REPAINT TRANSIT CENTER
 NORTH LOT
 1418 N. GOLDEN STATE BLVD.
 TURLOCK, CA 95380
 CITY OF TURLOCK
 CITY PROJECT# 24-02

SHEET NUMBER
C2

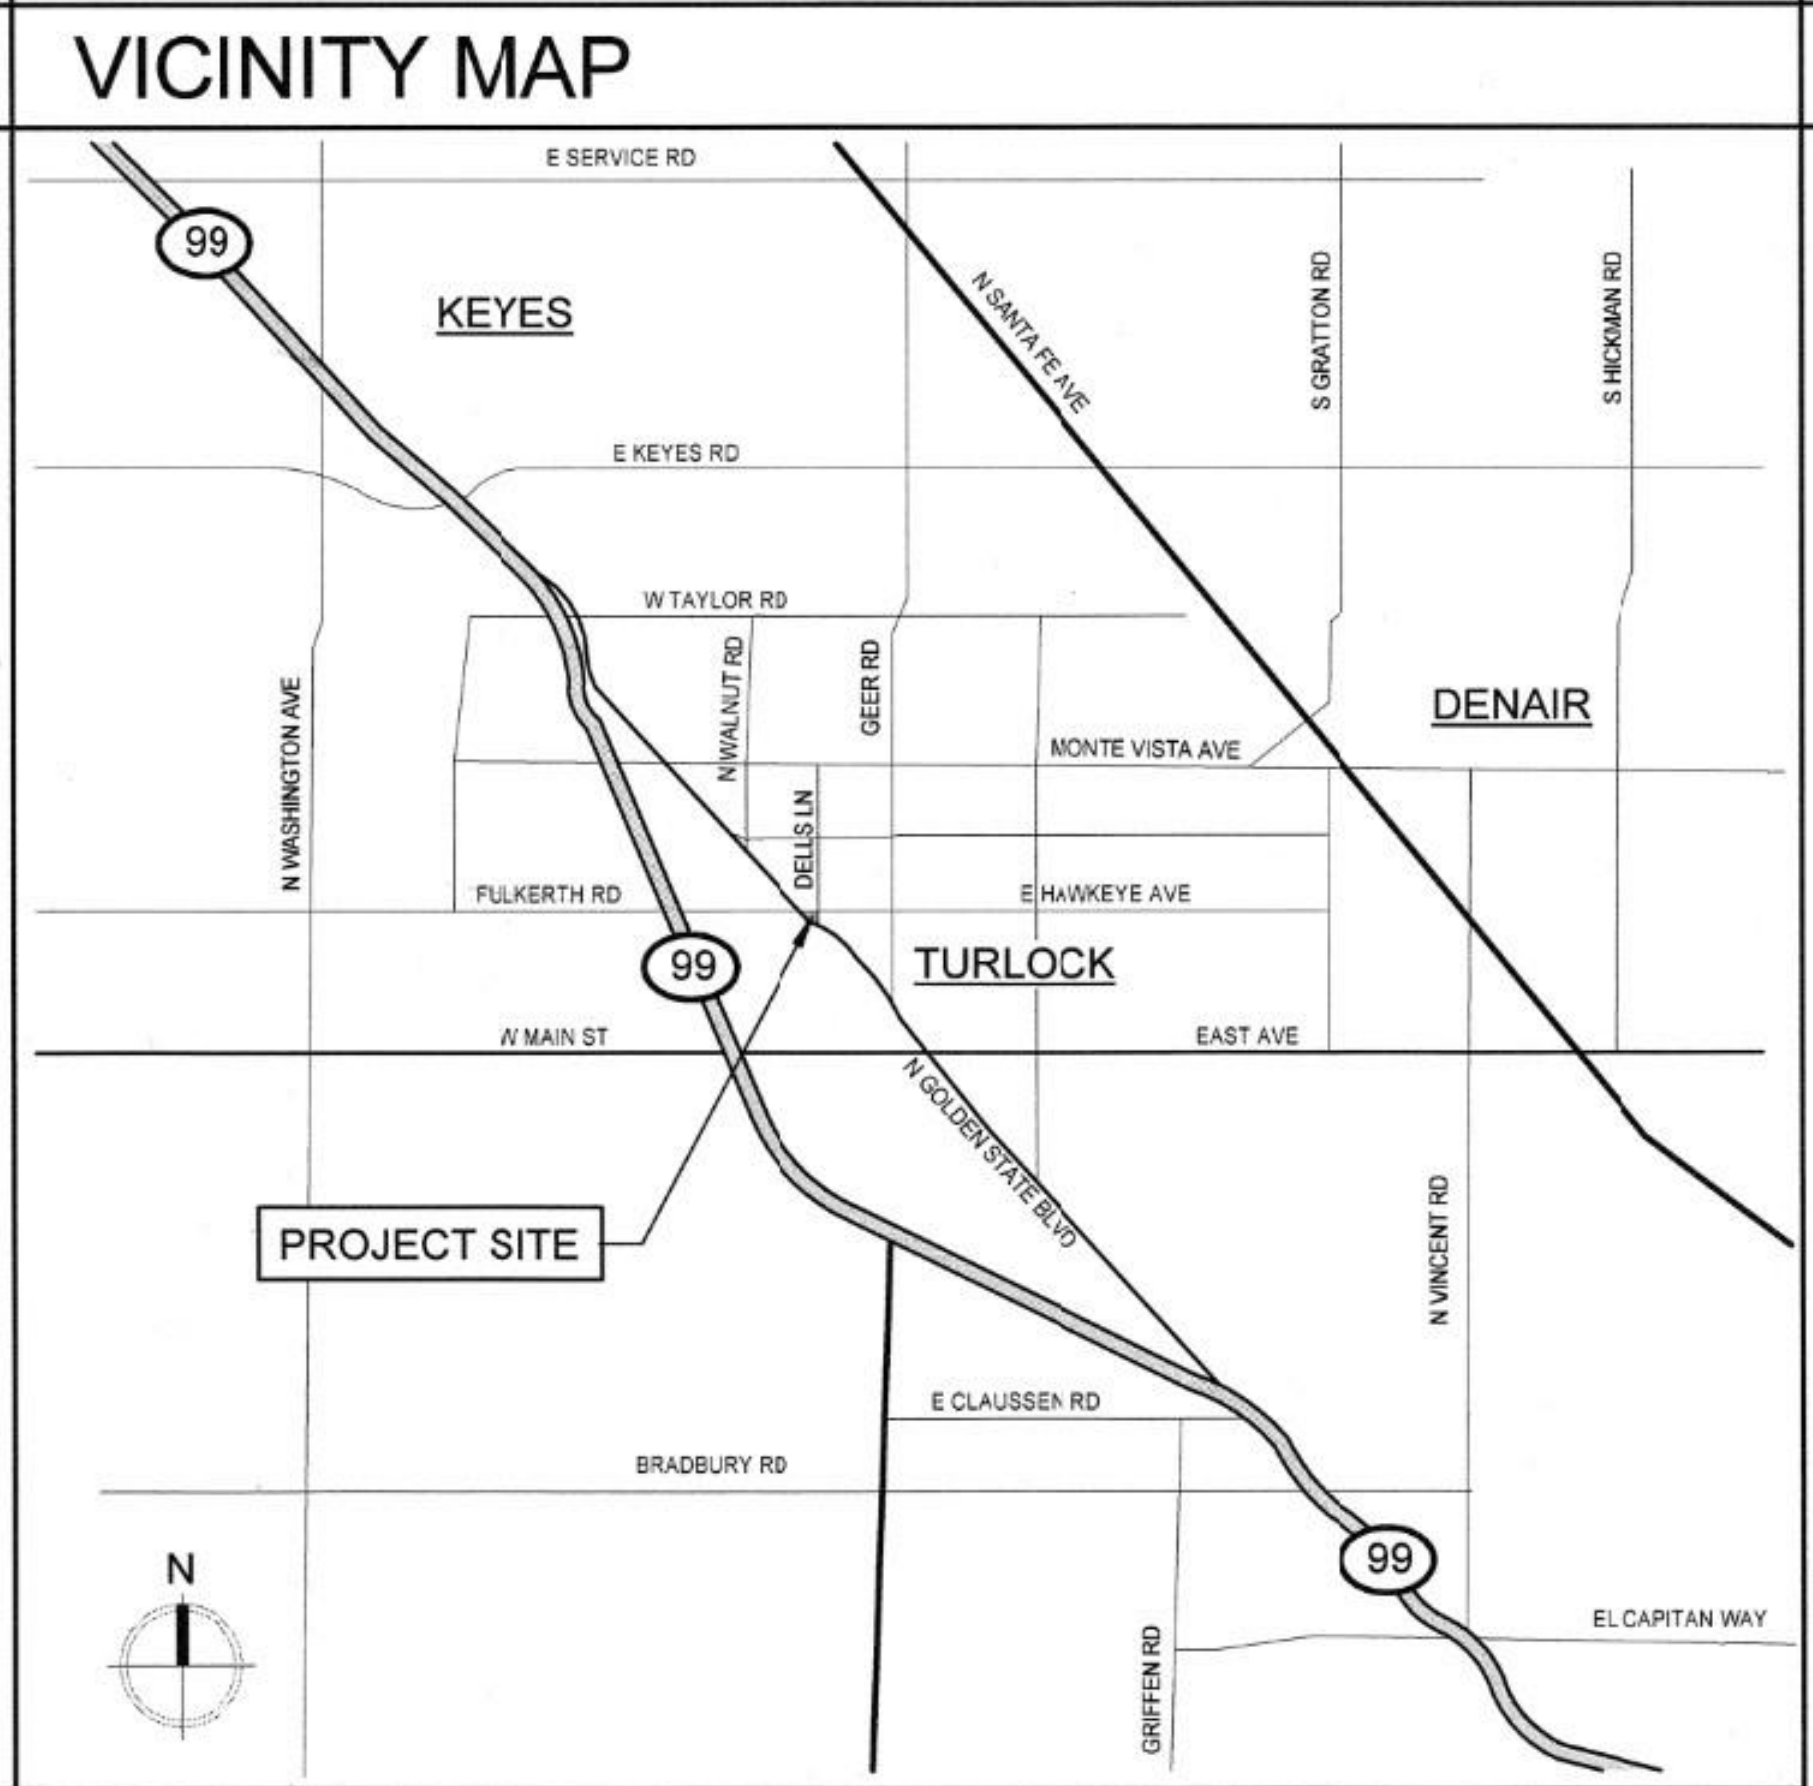
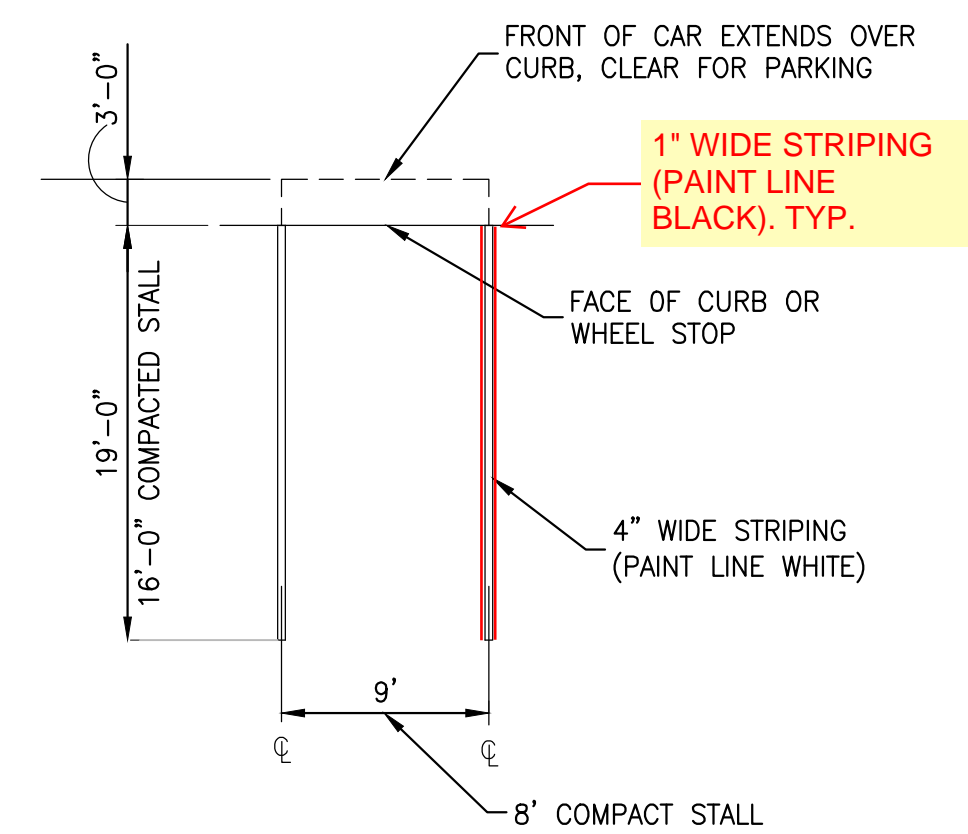
Repaint centerline per Construction Note 4. (Typ.) (37 LF Total).

Repaint Green EV Charging Symbol. Typ. (Total of 3 EA)

Paint "EV CHARGING ONLY" lettering. 12" minimum letter height.

50 LF (Total) for White Lines.

Repaint parking stalls per Construction Note 2. Install contract striping for parking stalls. (Typ.) (1,219 LF Total)

Repaint "COMPACT" lettering. (Typ.)

Increase width of access aisle from 5' to 8'.

Reduce width of access aisle from 8' to 5'.

Shift these (2) parking stall lines and accessible parking symbols southeast 3'.

Repaint loading zone per Detail 2 on Sheet A0.2.

54 LF of Blue Border Line.

Repaint arrows. (Typ.) (Total of 14 EA).

75 LF (Total) for White Lines.

Not shown on Plan, but there is a White Line to be repainted. (42 LF). Refer to Detail 2 on Sheet A0.2.

SHEET NUMBER
C4

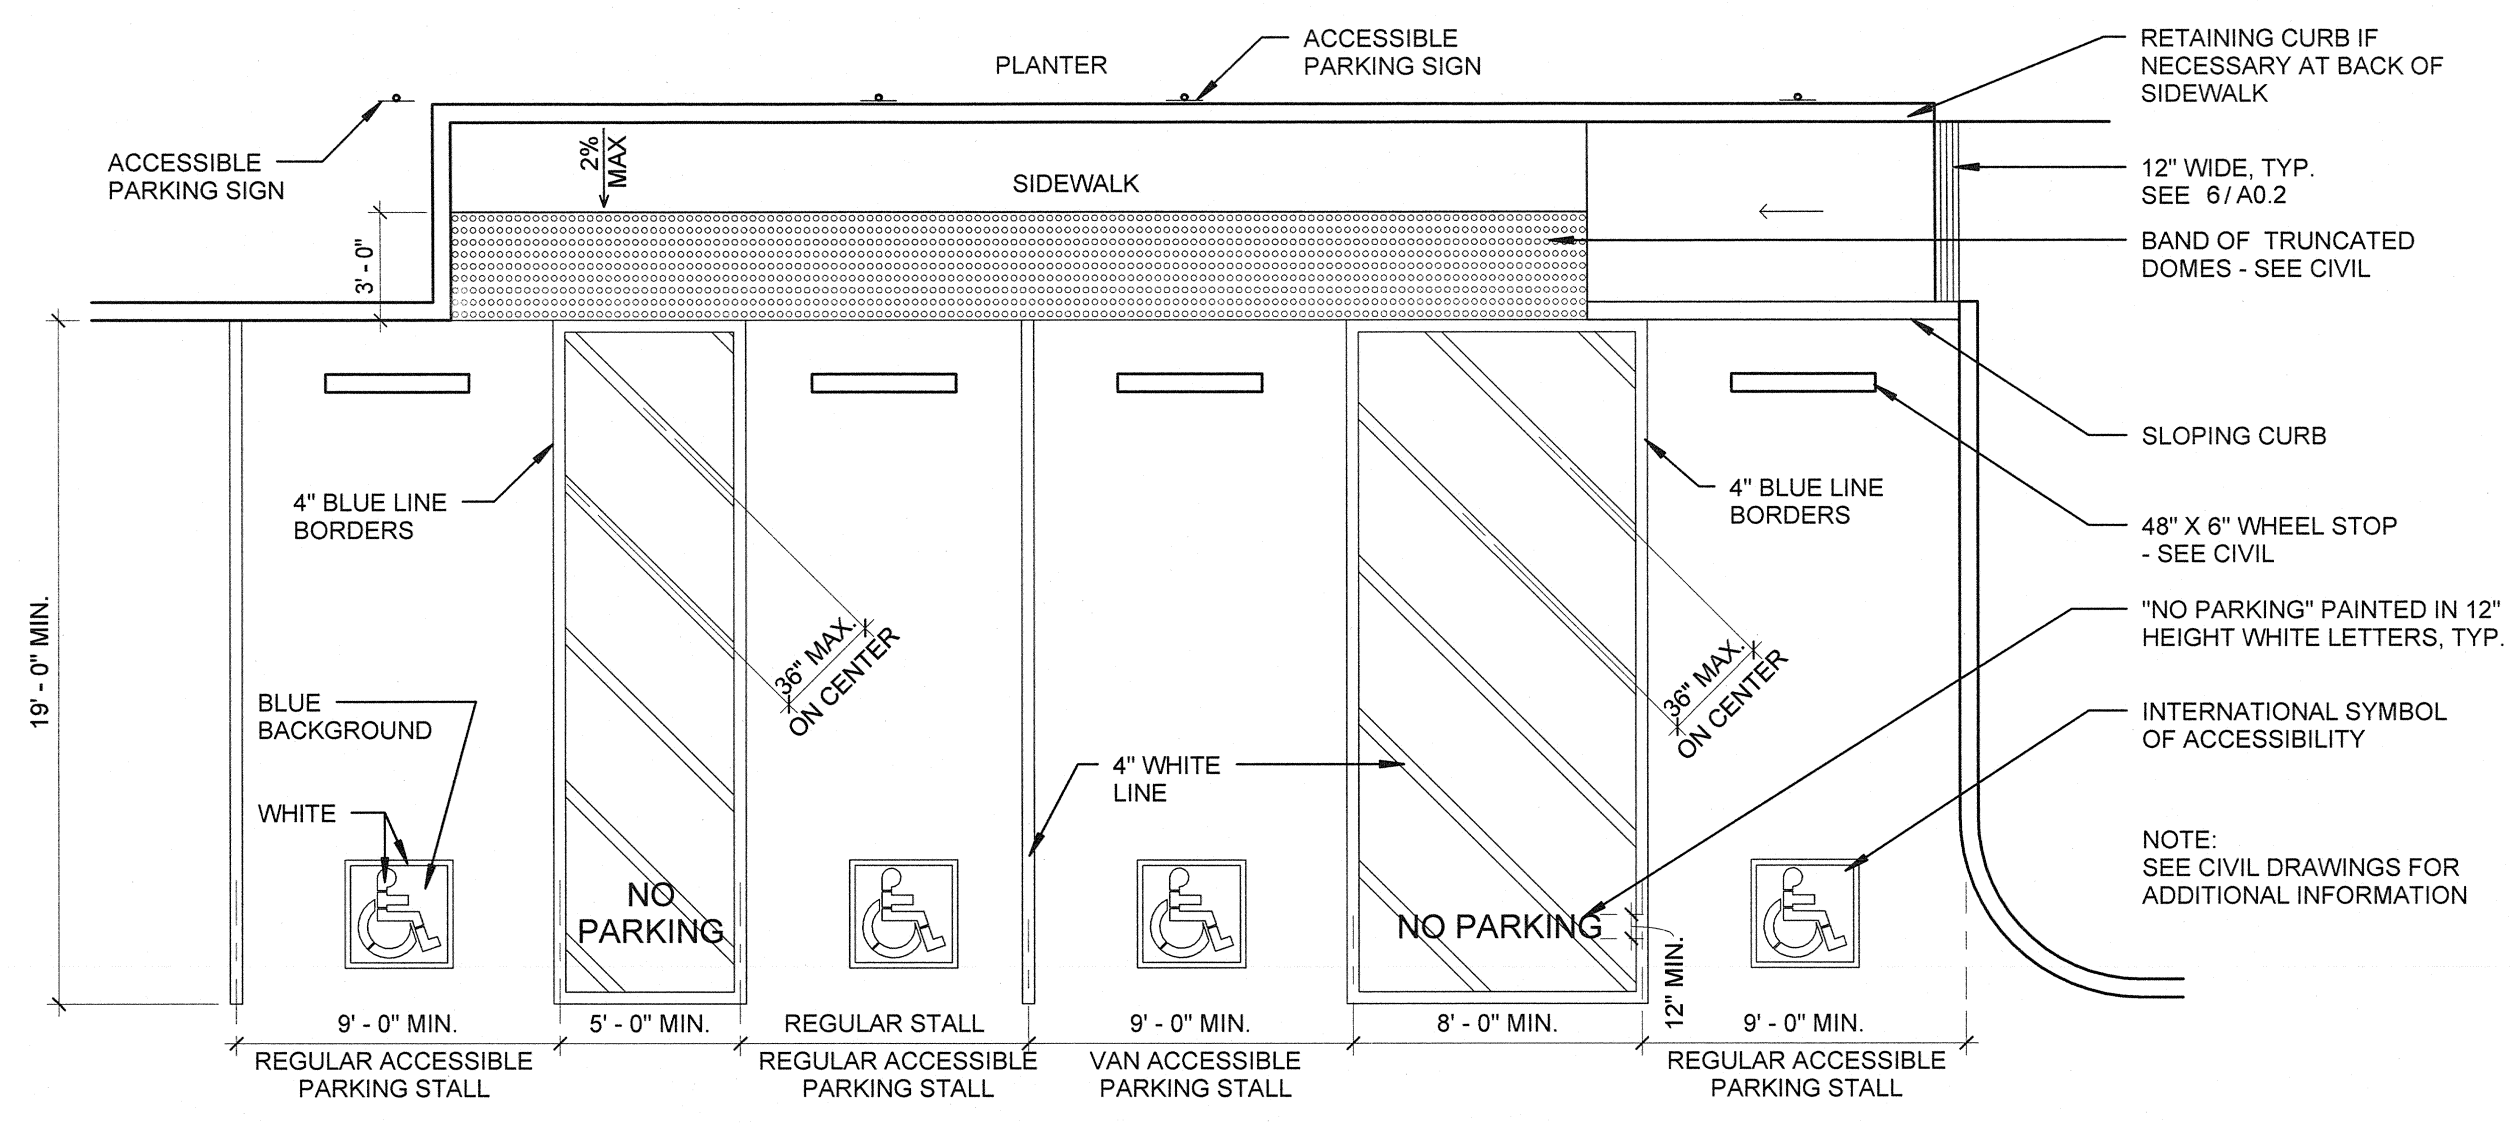
Remove and replace expansion joint filler materials along border of each separately colored zone (Typ.)

Approximately 361 LF total.

Use Sikasil 728-SL or approved equal.
